Re: Comments on the Exide Group, Inc. Mill River SedRAP and OLISP General Permit
Registration Form for Coastal Remedial Activities Required by Order

Comments of the Fairfield Conservation Commission
Concerning the Exide Group, Inc.
April 2012
Remedial Action Plan for Lead Impacted Sediments
February 27, 2013

Photo #1

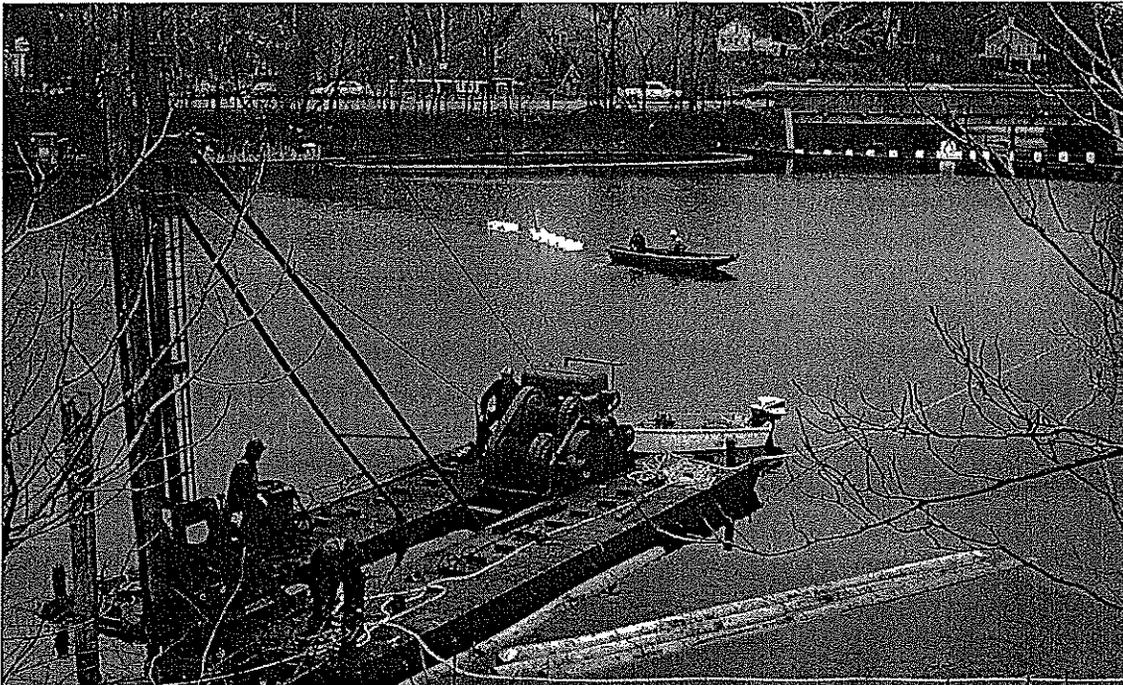
View of the 1983 Exide Mill River sediment remediation project. This is a hydraulic cutterhead dredge with shroud, variable-speed pump and cutterhead. The dredge shifts its position by moving along a cable suspended between timber pilings located around the shoreline. April 1983 tjs

The dredging project will do several things as observed in the enclosed 1983 and 1985 photos: To provide a clean dredging bottom condition, the removal of submerged debris and the dredge's mechanical agitation of the bottom sediments will leave a smooth, level, homogenized mud substrate having little diversity and value to plants and animals.

Exide should compensate for the increased anaerobic bottom conditions by submitting revised plans providing for the refilling of its dredged sumps with clean soil material and by restoring the significant submerged structural habitat elements, logs, stones, etc., on the bottom following the dredging project.

Photo #2

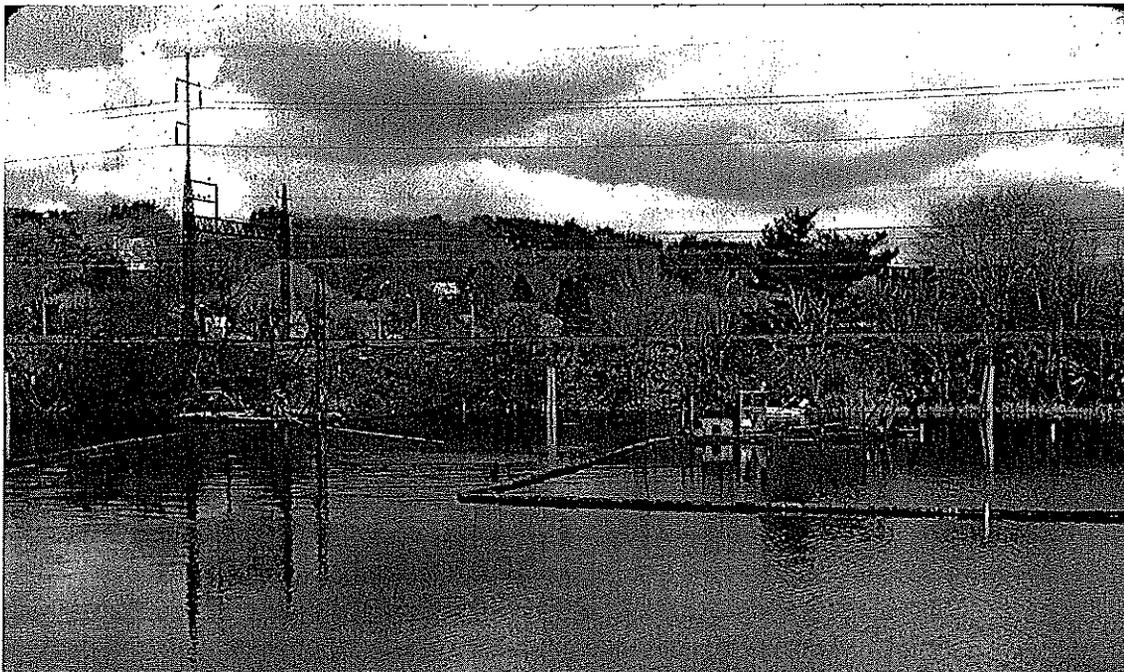
View of Exide's 1983 Mill River sediment Lead remediation project. The work barge in the foreground is driving timber piling along the shoreline to support the cable for shifting the dredge as it cuts into the river bottom. '83 tjs

Photo # 4

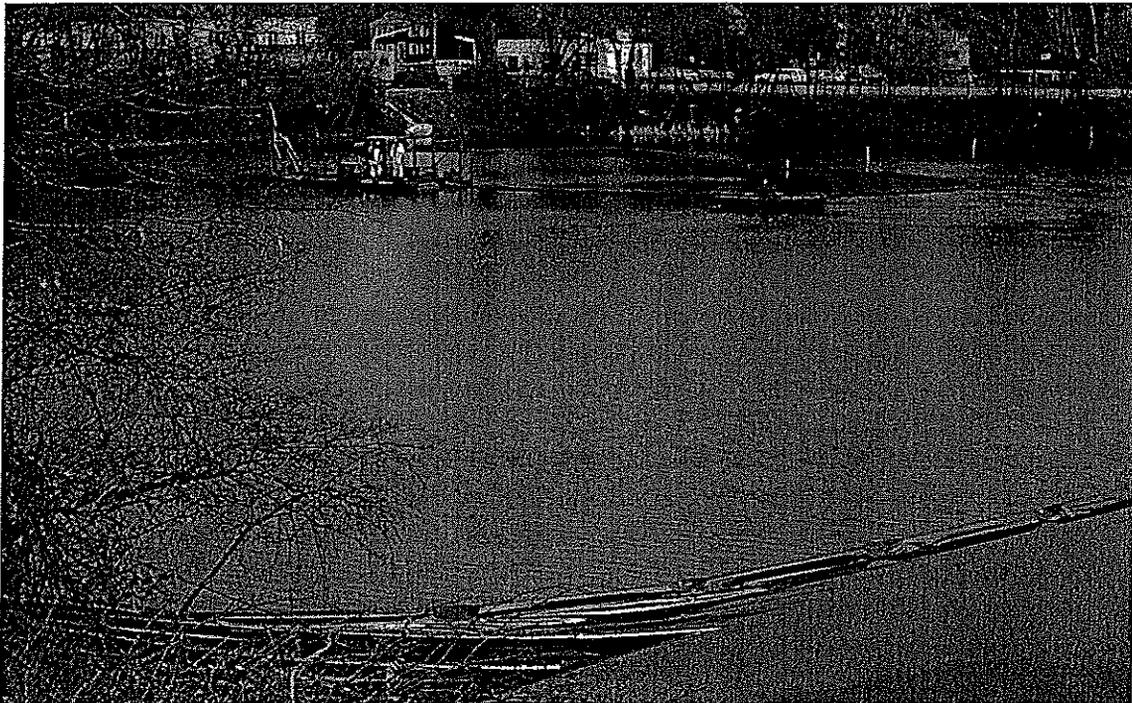
View of Exide's 1983 remediation of Mill River mill pond looking from the railroad toward the Post Rd. The dredge cell silt curtain to the right is suspended from the floating boom and is intended to protect the open water in the Mill River. Note the oil slick in the foreground contained within the boom. April 1983 tjs
